PRELIMINARY PLANS

INITIAL ISSUE: 01/30/23
REVISIONS:
03/13/23 CITY COMMENTS

HIGHVIEW PARK
SHAKOPEE, MINNESOTA

SHEET NUMBER:
34 OF **119**
PRELIMINARY UTILITY PLAN
PROJECT NUMBER: 0033370.00 DATE: 03/13/23

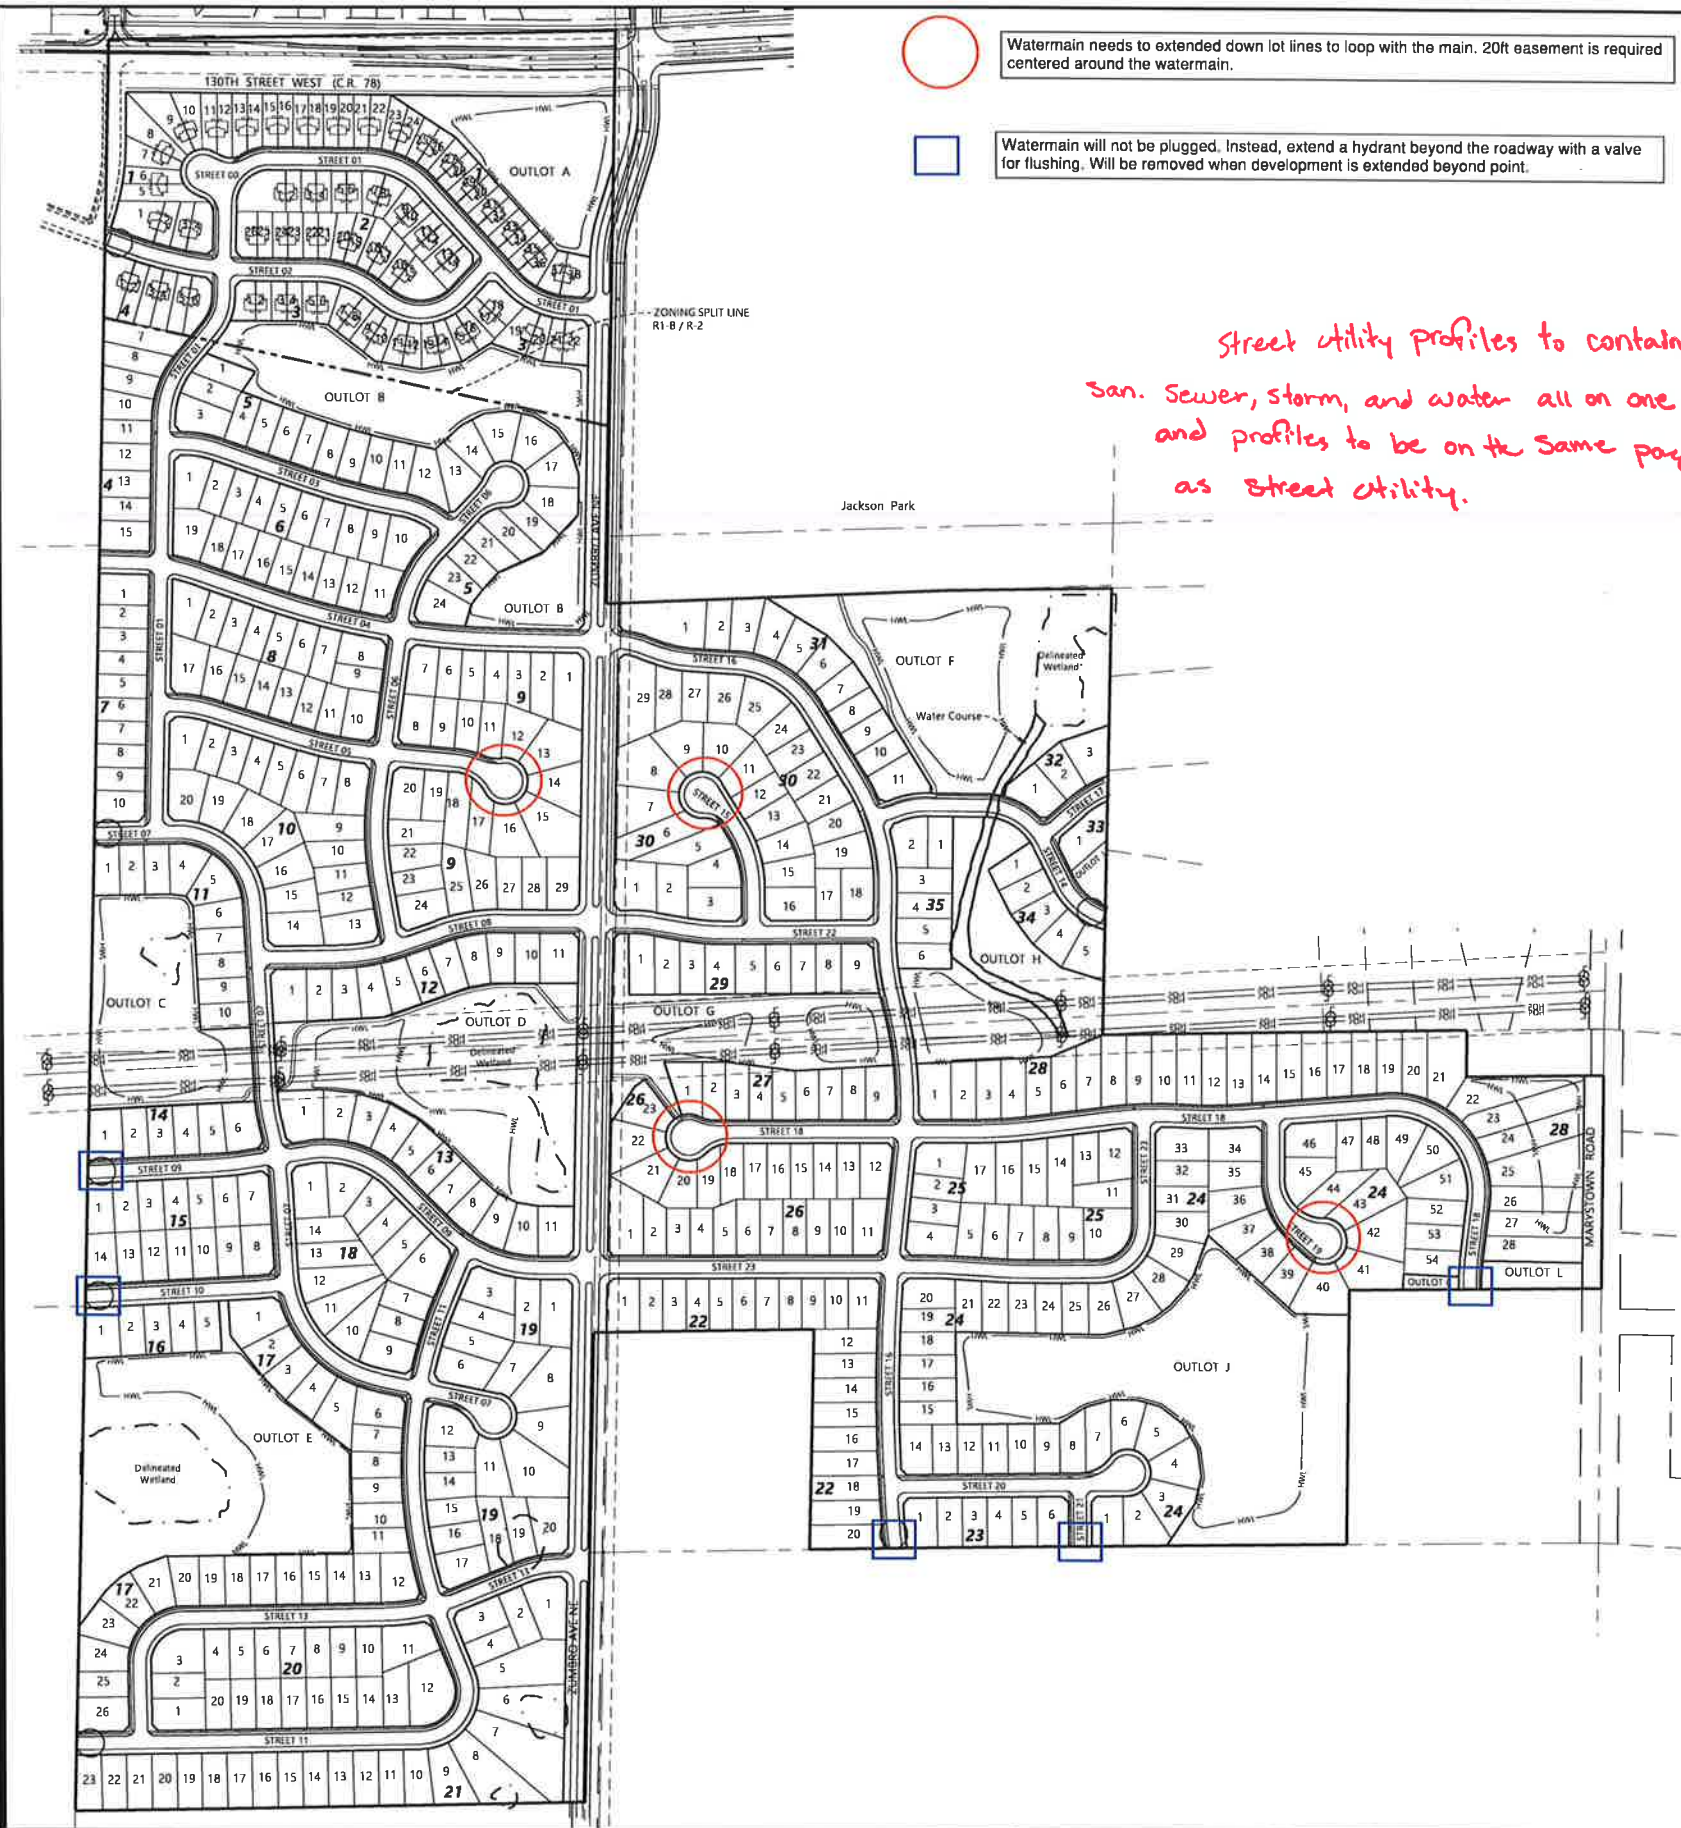
- Watermain needs to be extended down lot lines to loop with the main. 20ft easement is required centered around the watermain.
- Watermain will not be plugged. Instead, extend a hydrant beyond the roadway with a valve for flushing. Will be removed when development is extended beyond point.

Street utility profiles to contain San. Sewer, storm, and water all on one and profiles to be on the same page as street utility.

SHEET NUMBER:
45 OF **119**
DATE: 03/13/23
PROJECT NUMBER: 0033370.00

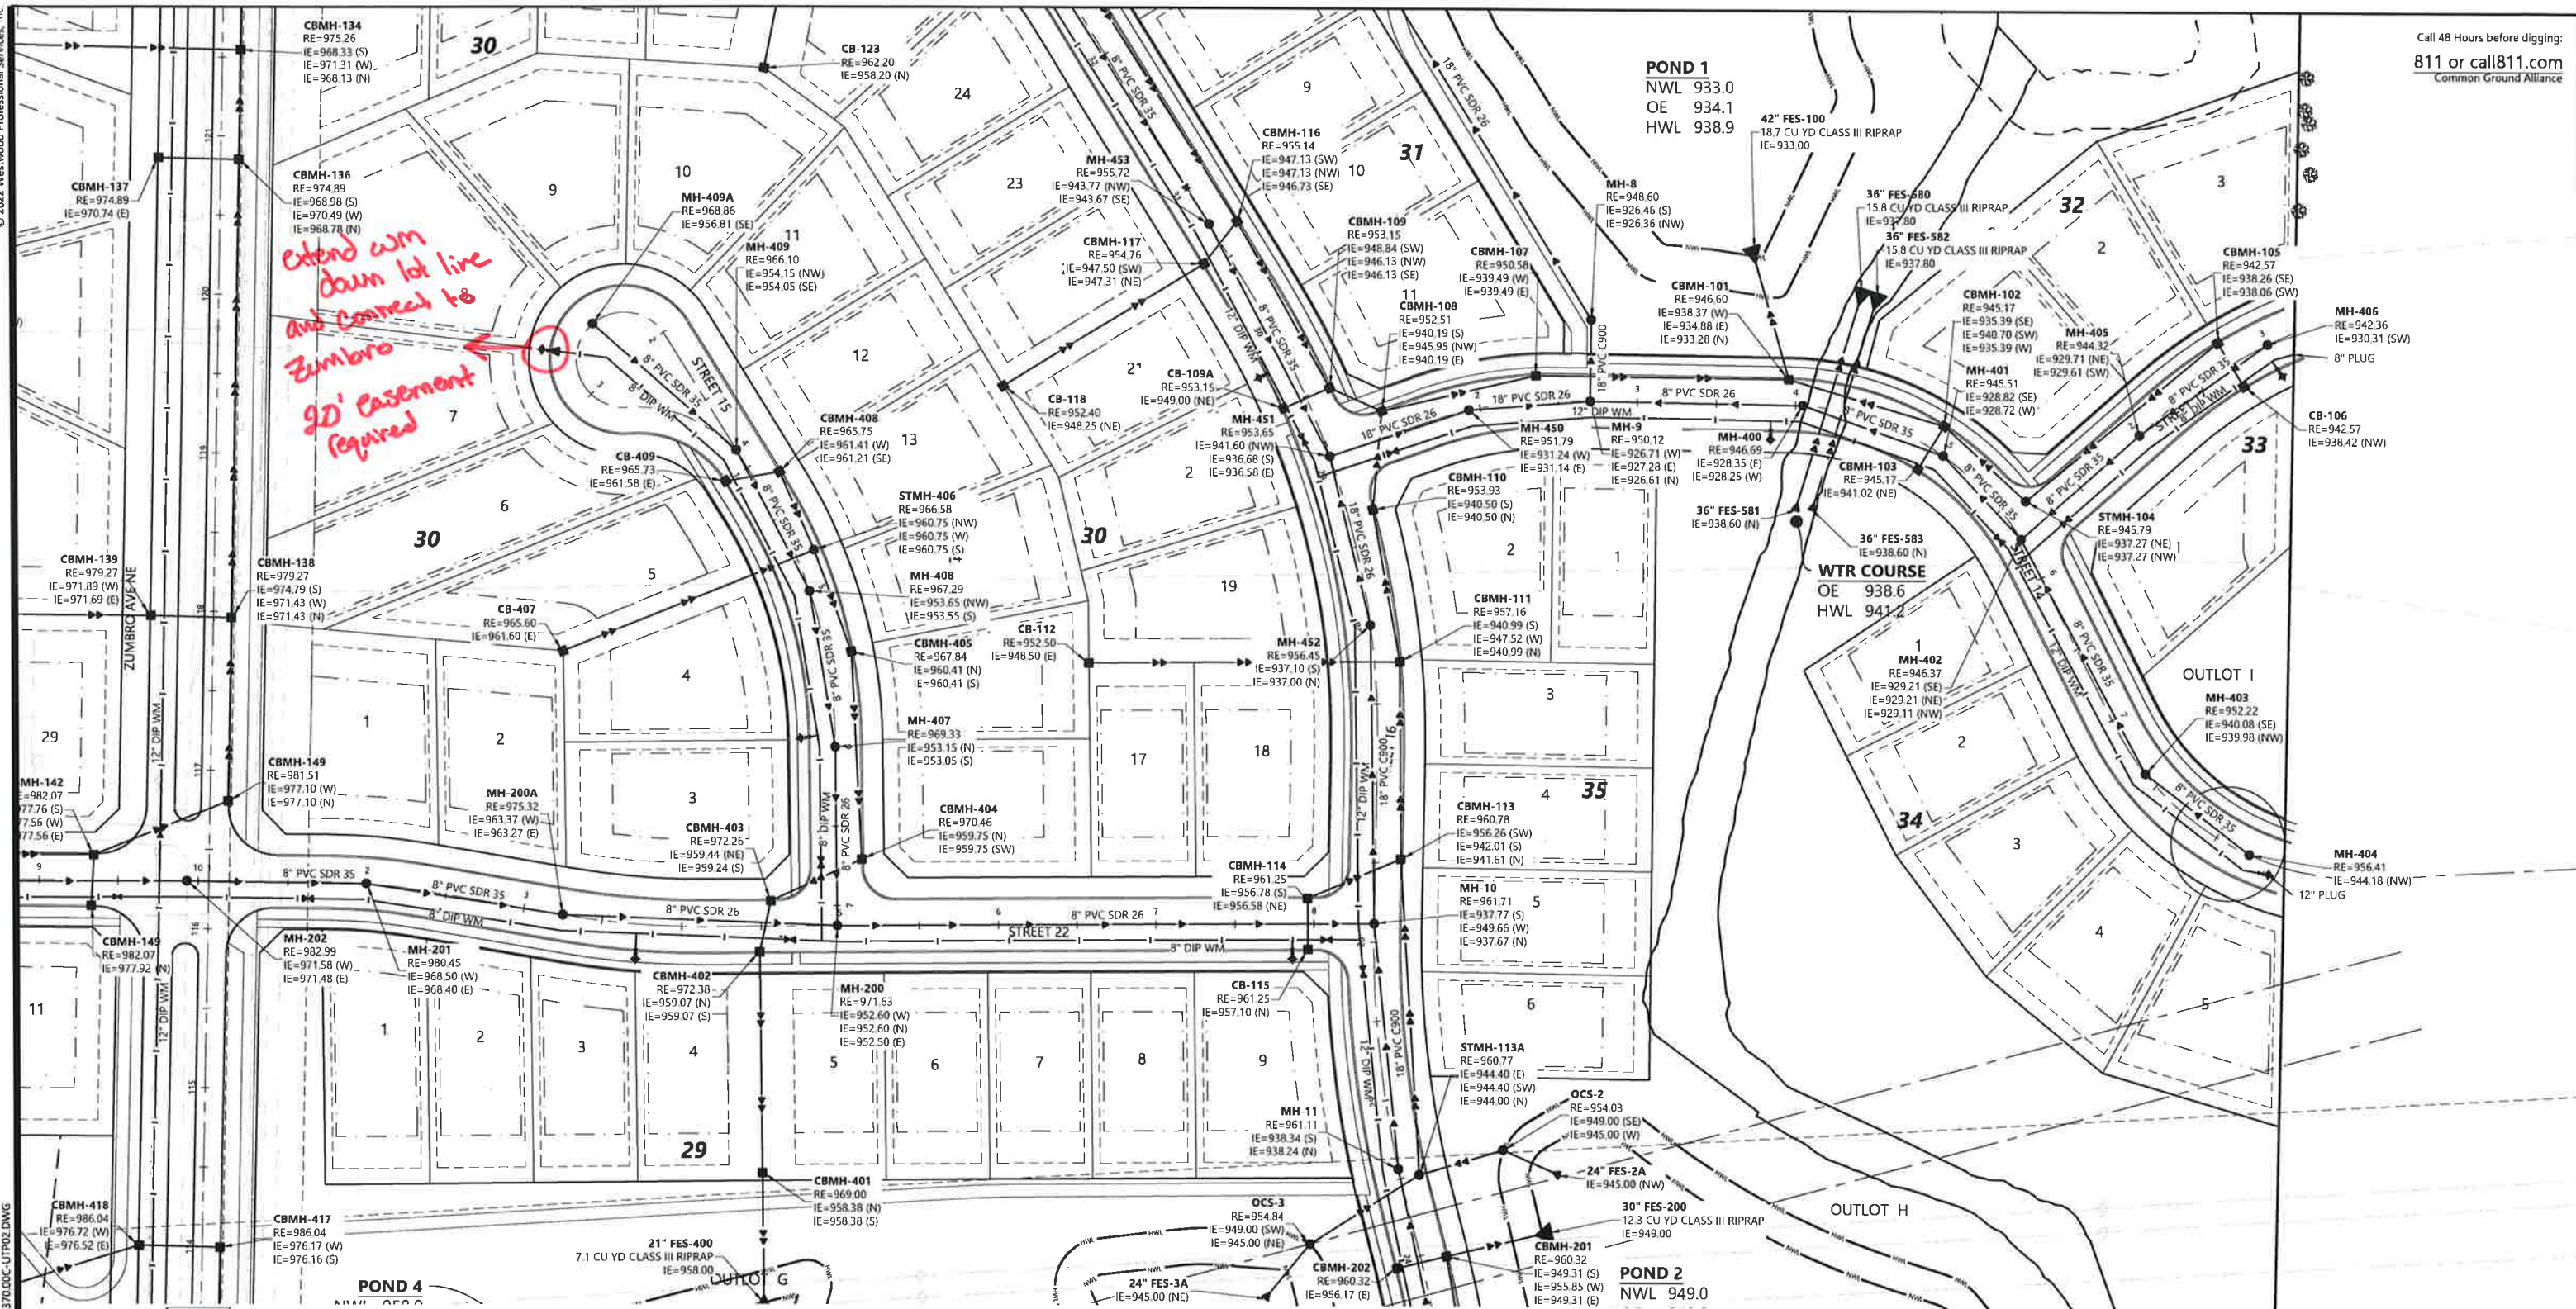
Extend w/m
down lot line
and connect to
Zumbro
90' easement
Required

SHEET NUMBER:
48 OF **119**
DATE: 03/13/23
PROJECT NUMBER: 0033370.00

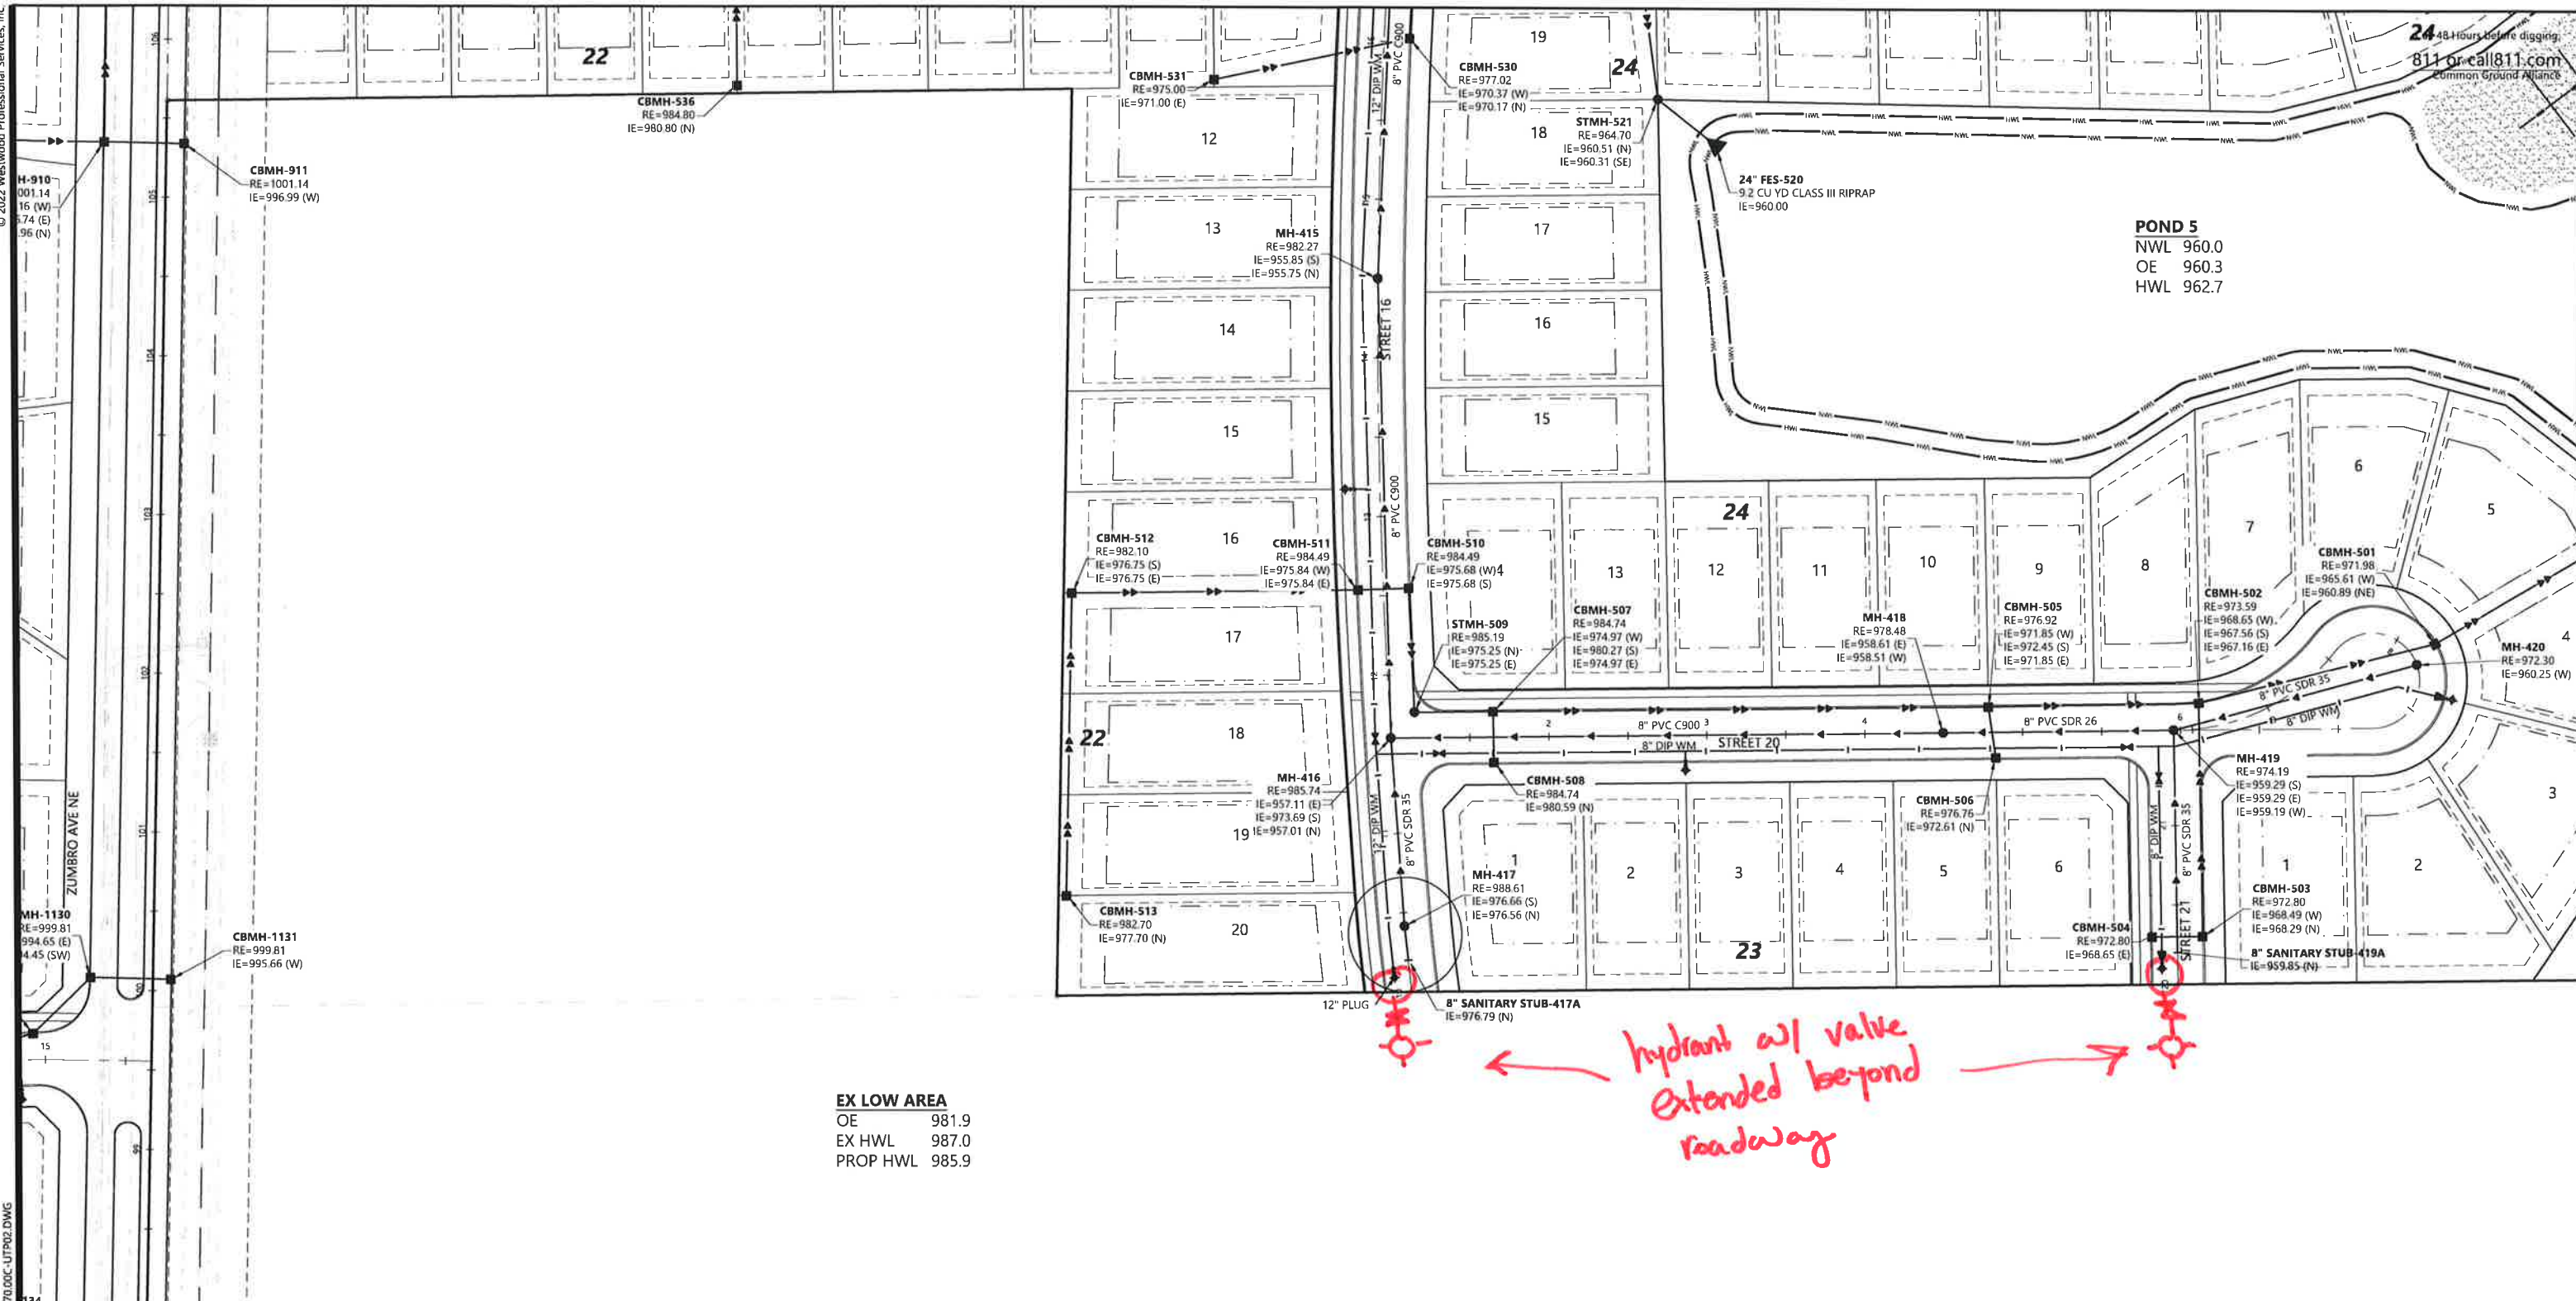
Hydrant w/ valve
Extended beyond
roadway
